**Public Comment No. 894-NFPA 70-2021 [Global Input]**

**Public Comment No. 1220-NFPA 70-2021 [Definition: Branch Circuit, Appliance.]****Branch Circuit, Appliance (Appliance Branch Circuit) .**

Figure 2

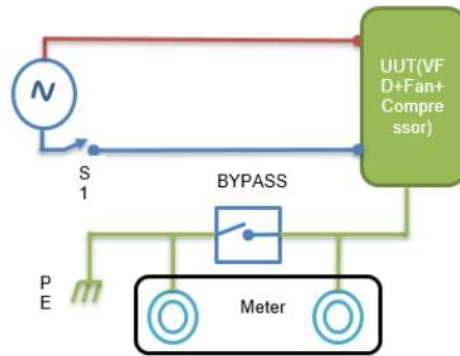
Simplified Test Set-up (see attached figure#2)

FIGURES 1-4: LARGE PERCENTAGE OF HOME IMPROVEMENTS DONE BY DIY'ers; "PROFESSIONALS" CAN INCLUDE PAINTERS AND HANDYMEN, NOT ALWAYS ELECTRICIANS.

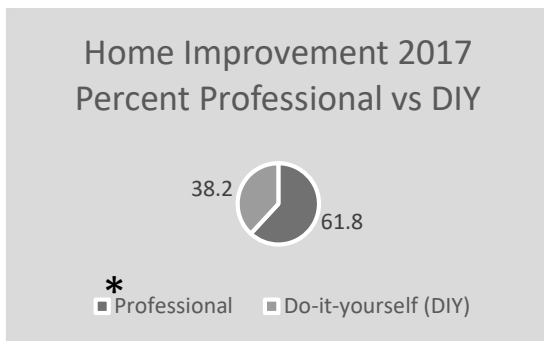
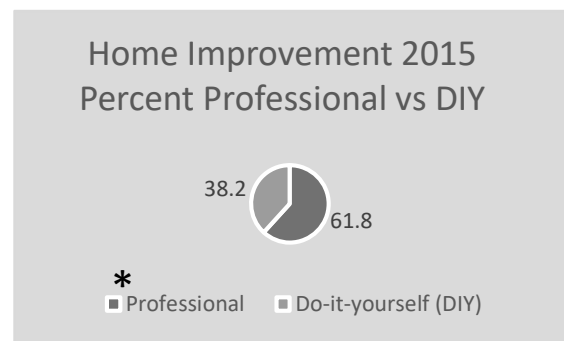
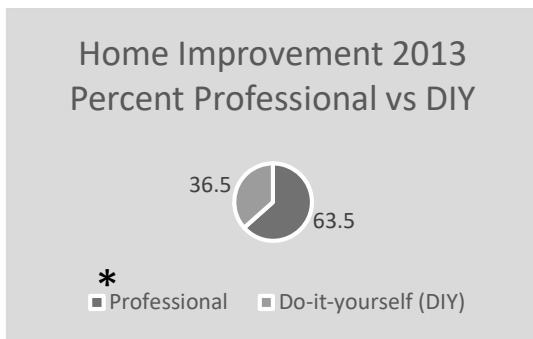
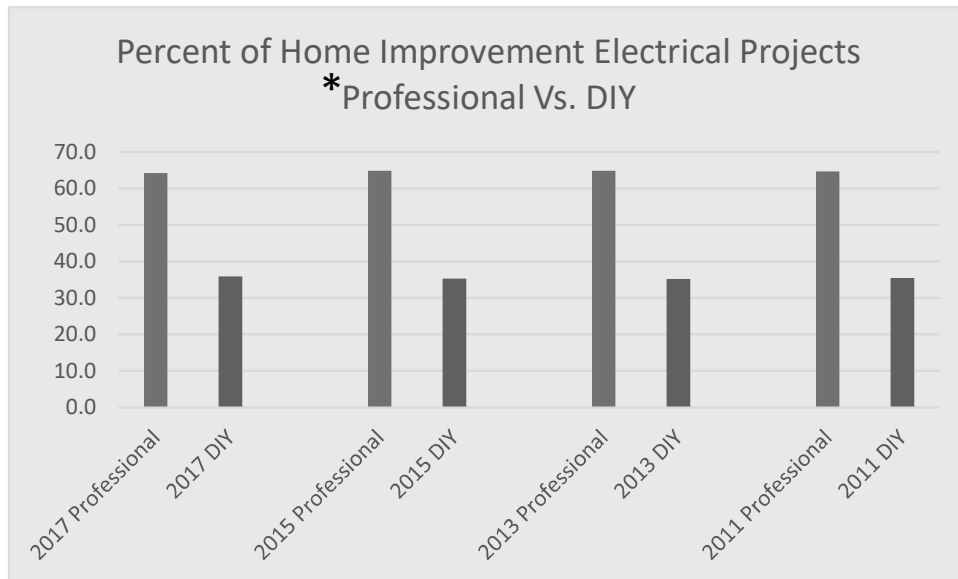
performed by the homeowner. Surprisingly, the statistics also show a fairly consistent percentage of electrical renovations that are DIY. Permits are rarely taken out for DIY equipment replacements or renovations. That is sometimes the case with flipped homes. As a result, DIY work is rarely inspected by jurisdictional electrical inspectors. Even when permits are taken out, there is no guarantee that the work will be performed by professionals or that it will be inspected. Many jurisdictions will only spot check the work of homeowners because inspections cost money and if there is no inspection, the jurisdiction can just collect the permit fee. For those who are classified as professional, how many of the practitioners are electricians? How many are just handymen? Figures 1 through 4 illustrate the percentages of home improvement projects for a two-year period ending in 2017, 2015, 2013, and 2011. Figure 5 illustrates all of the electrical home improvement projects reported by the survey from 2010 through 2017. The background data is in Annex A.

Figure 4: 14/2 CCA Spaced 12" in R43 Insulation at 10 Amps in Ceiling Configuration

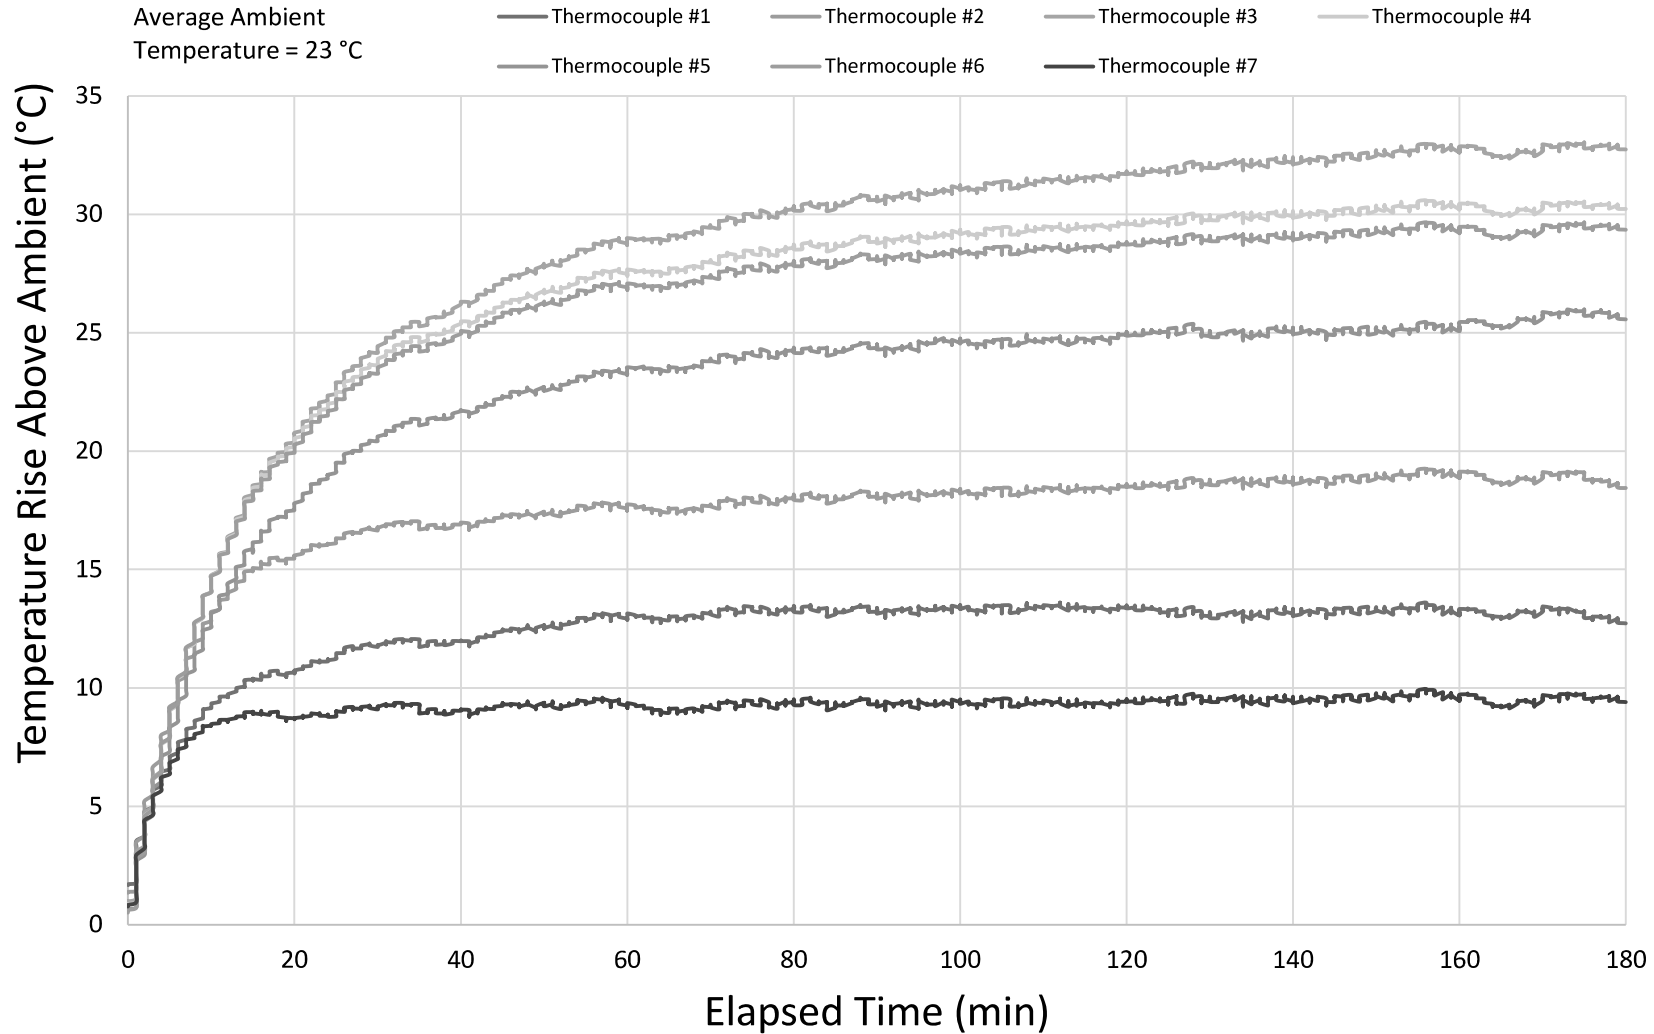
See Figures 4 and 5 below for the temperature profile for AWG 14/2 copper-clad aluminum and 14 AWG THHN copper-clad aluminum while the apparatus was in the ceiling orientation. See Figures 6 and 7 for data in the wall orientation.

Figure 210.52(C)(2) Determination of Area Behind a Range, Counter-Mounted Cooking Unit, or Sink.

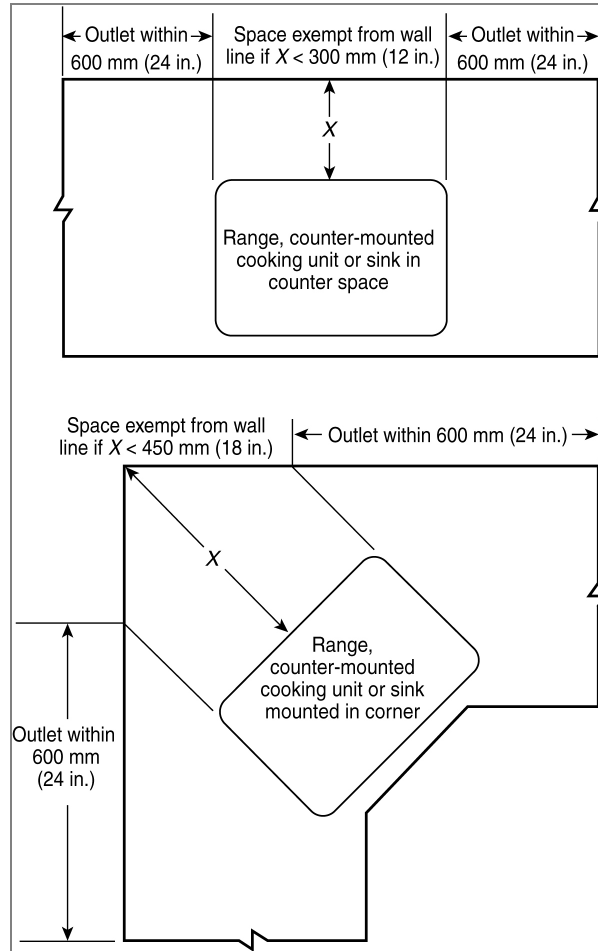
Exception No. 2: Where a required receptacle outlet cannot be installed in the wall areas shown in Figure 210.52(C)(2), the receptacle outlet shall be permitted to be installed as close as practicable to the countertop area to be served. The total number of receptacle outlets serving the countertop shall not be less than those required in 210.52(C)(2). These outlets shall be installed in accordance with 210.52(C)(4)(1) or 210.52(C)(4)(2).
